CITY OF ALBUQUERQUE

**Re: Santuario De San Martin De Porres Church
8301 Camino San Martin SW
Request for Permanent C.O. - Accepted
Engineer's Stamp dated: 10-29-14 (M10D002)
Certification dated: 1-14-16**

GRADING AND DRAINAGE PLAN

C-101

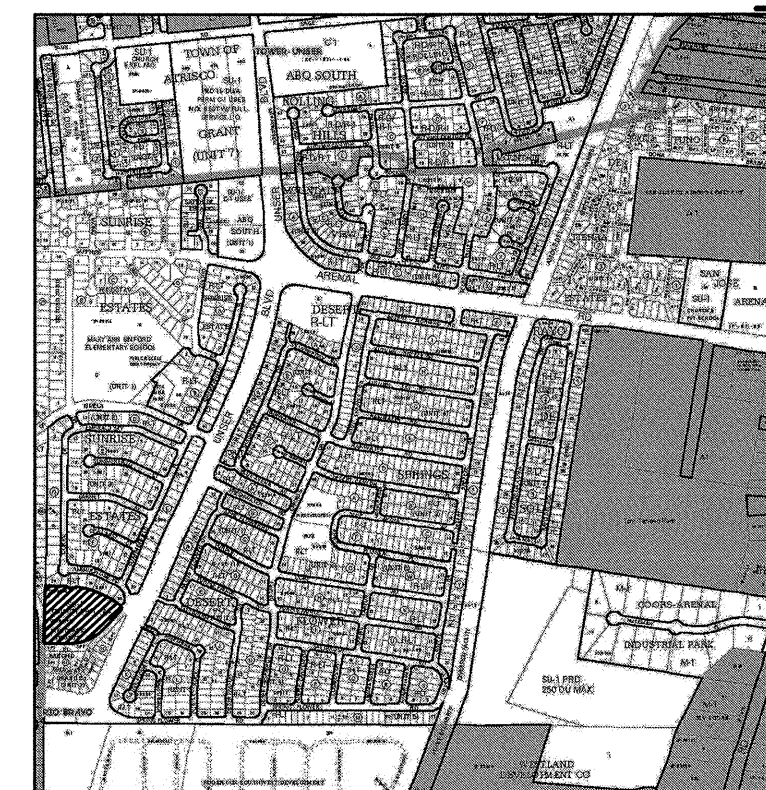
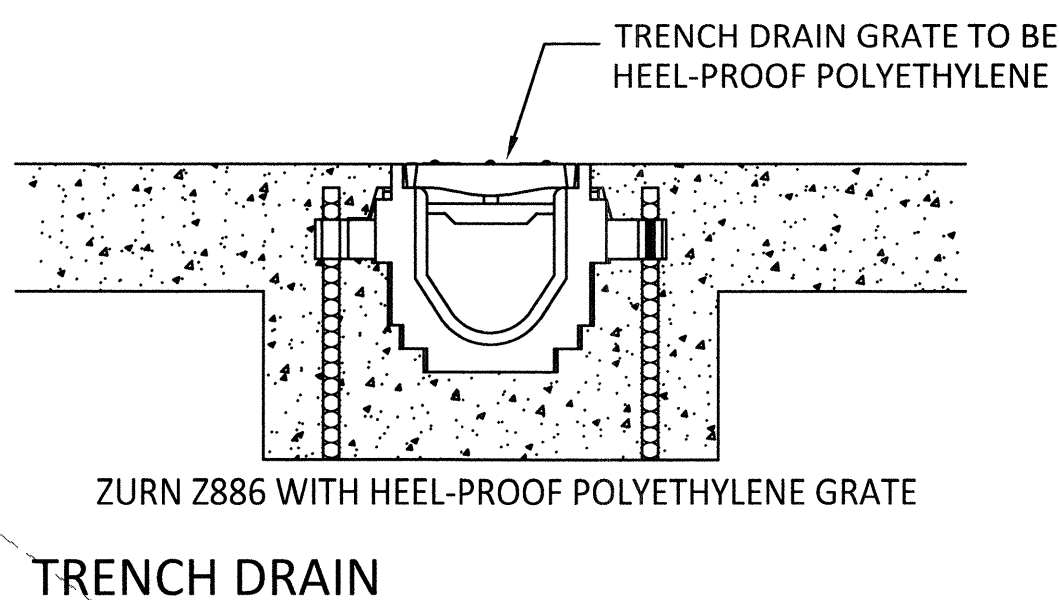
I was at the site today for the hydrology CO. The drawing calls out for 3' curb openings. Most of the openings are approximately 17". Please see attached pics of a couple of them. Would you please confirm that this will have no impact on the drainage of the site? Thank you.

I noticed the narrower curb openings also when I visited the site. With the multiple number of curb openings designed and constructed the narrower (17") width will not be a problem.
